SECTION 00 91 13.02 - ADDENDUM 2

- A. Project Name: ISU Science Rooms 018, 022, 138.
- B. Owner: Indiana State University Board of Trustees.
- C. Owner Project Number: ISU Bid No. B0028832.
- D. Architect: arcDESIGN.
- E. Architect Project Number: 26139.
- F. Date of Addendum: Friday, August 6, 2026.

PD201

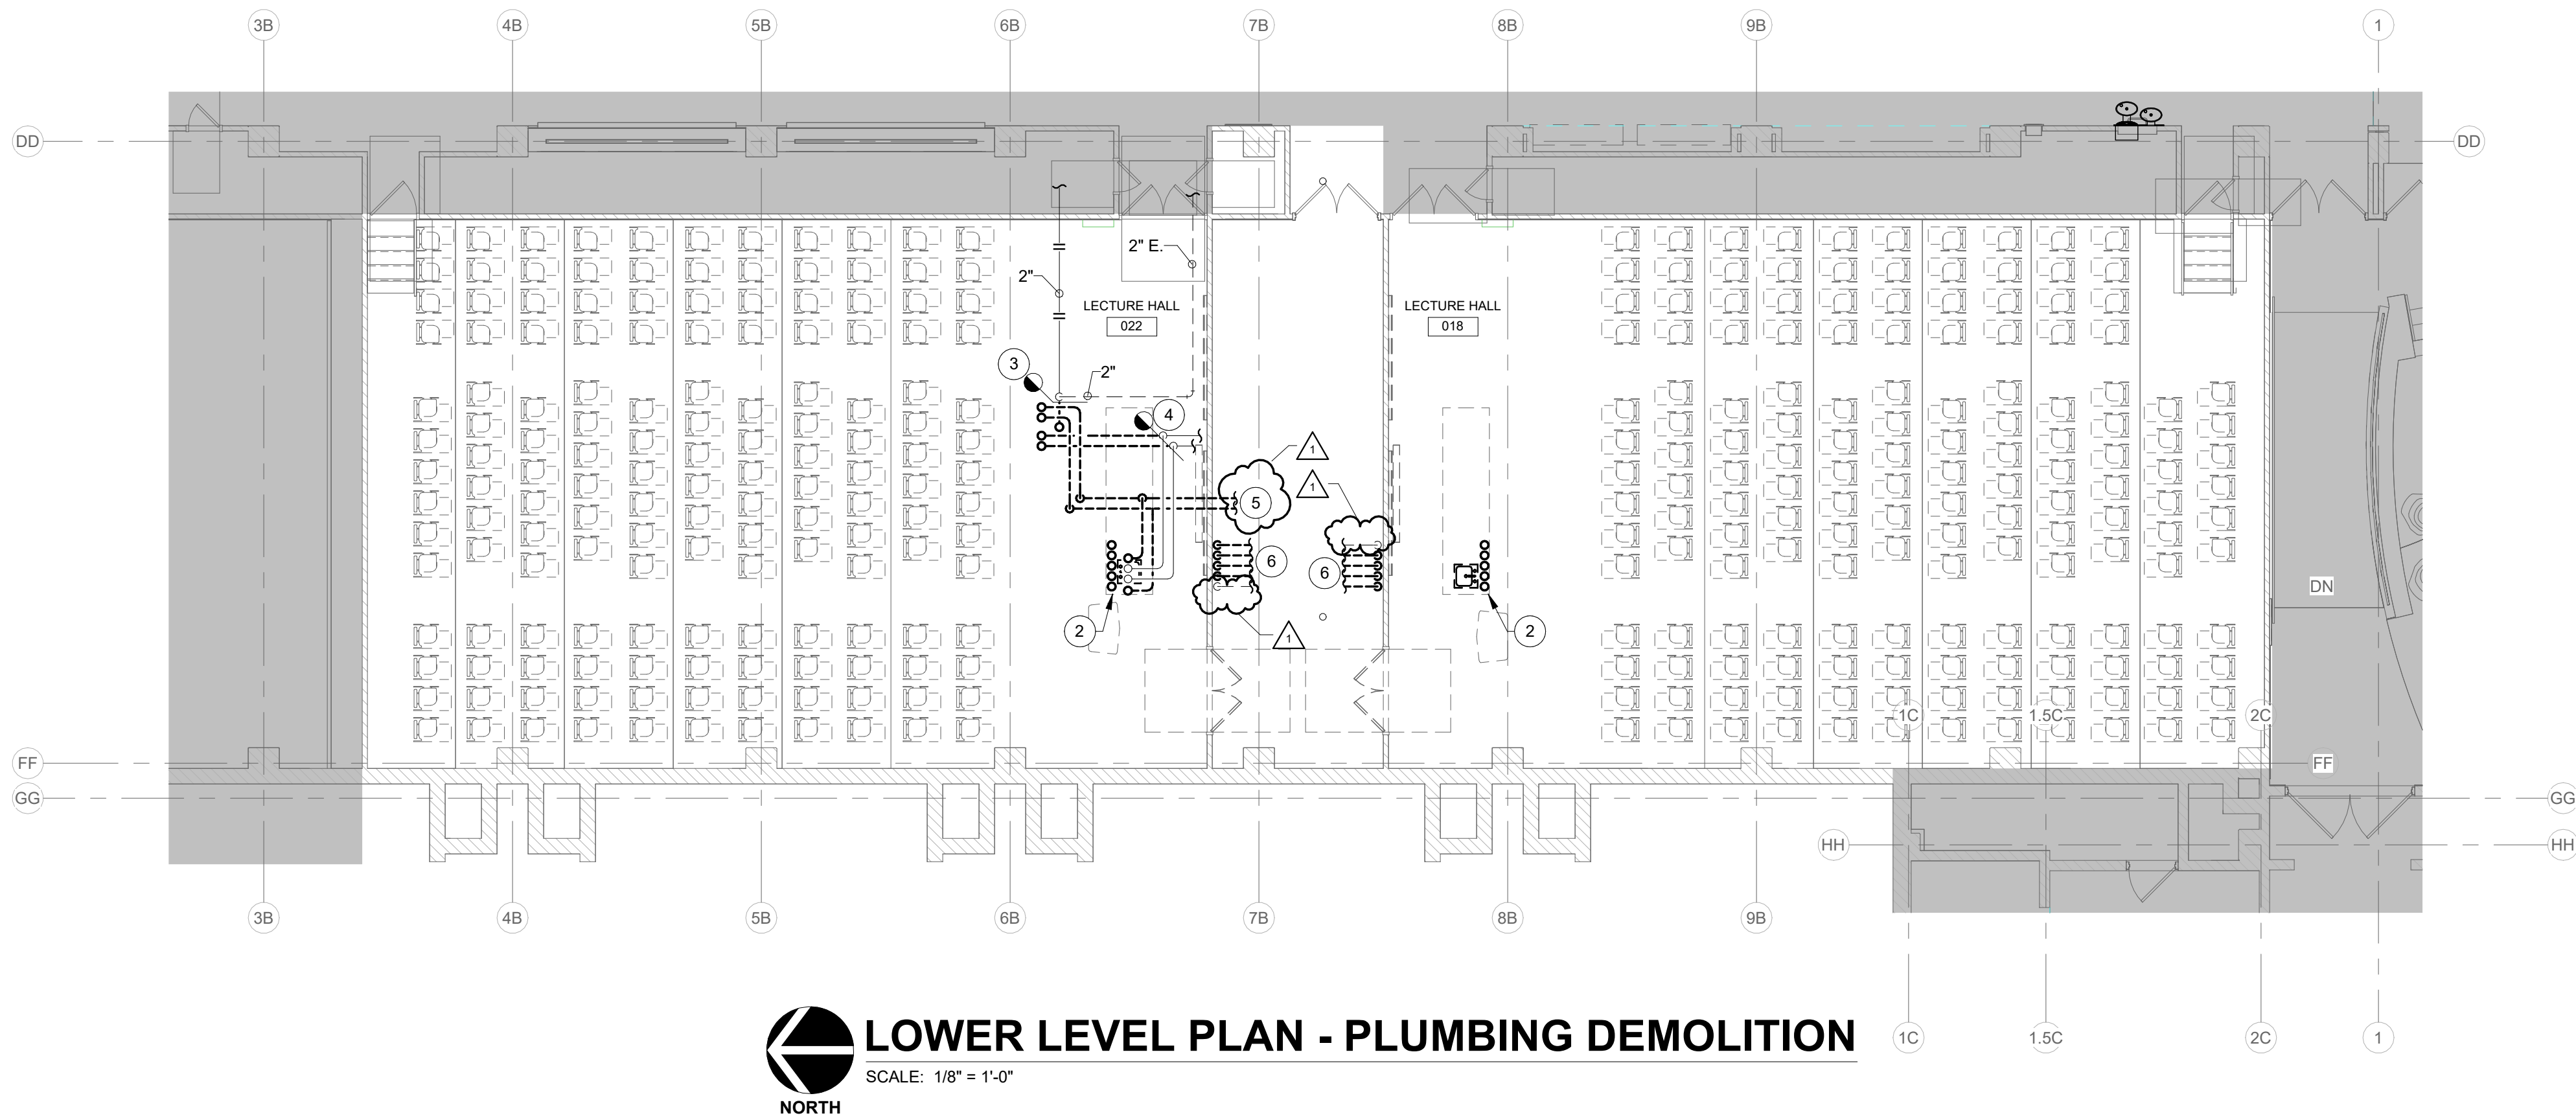
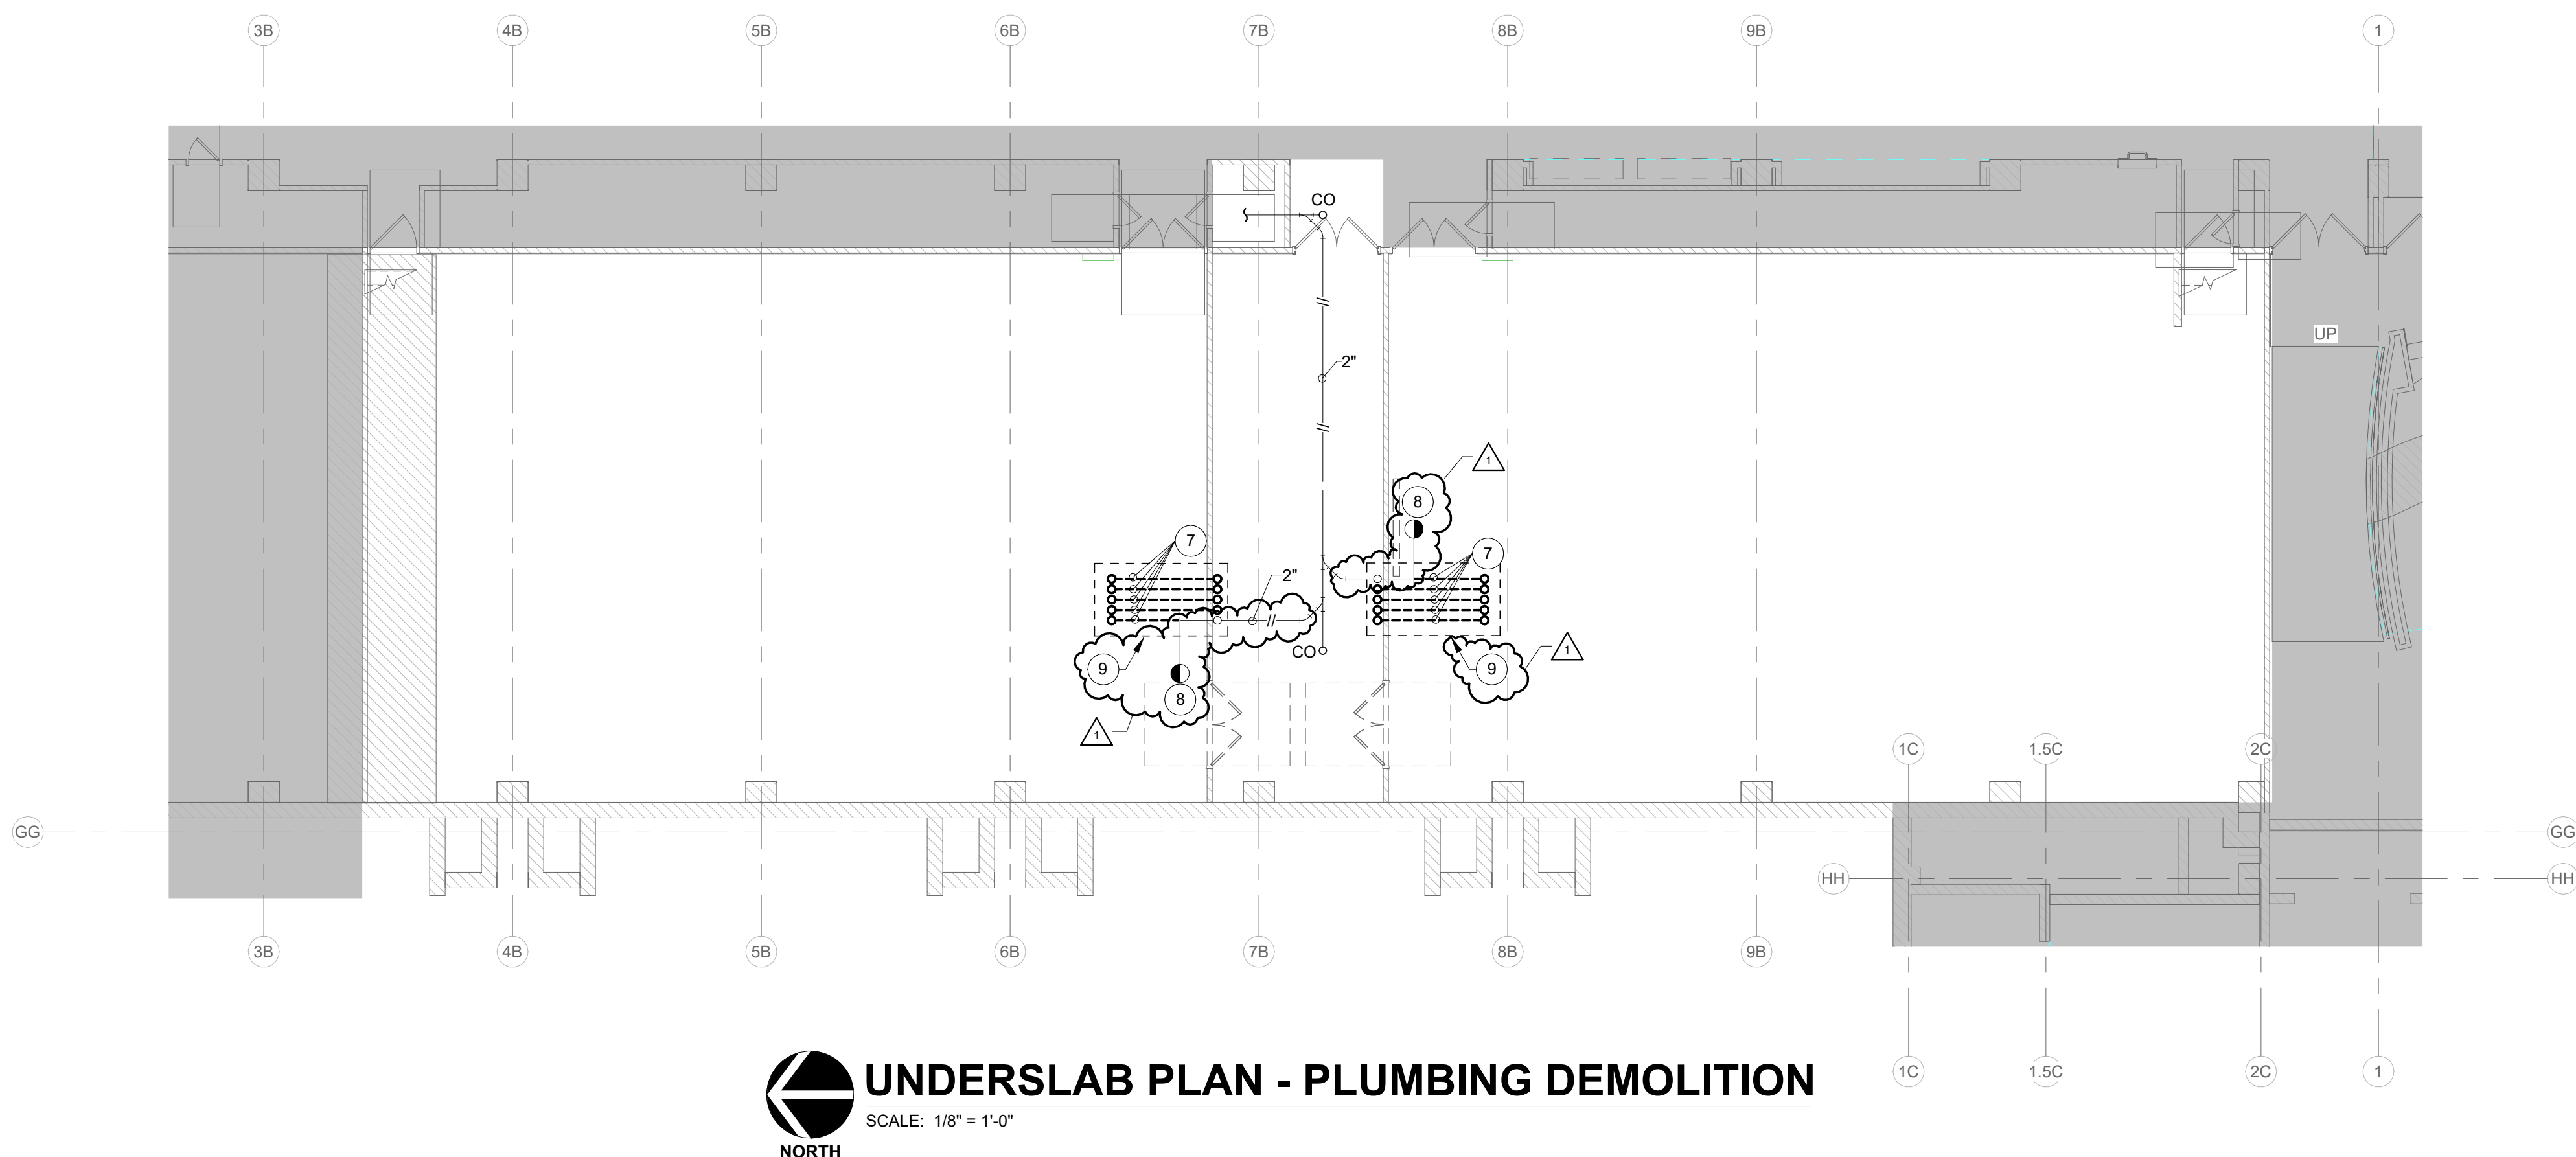
- A. Question: Drawing PD 201 shows the acid waste line being capped off inside the Prep Room between Rooms 018 and 022. This would require saw cutting in that room. Is it appropriate to cap that waste line off inside the existing trenches (as close to the wall as possible) in 018 and 022?
 - 1. Answer: Yes. The waste line, with the addition of a cleanout, can be capped in the trench close to the wall, avoiding disruption in the adjacent Prep Room.
- B. Question: Do the chases in the Prep Room need to be removed and patched or can services be capped at the trench or above the ceiling?

1. Answer: Capping services in the trench or above the ceiling in the adjacent Prep Room is acceptable. Chase removal should not be required in order to successfully abandon and cap the services.
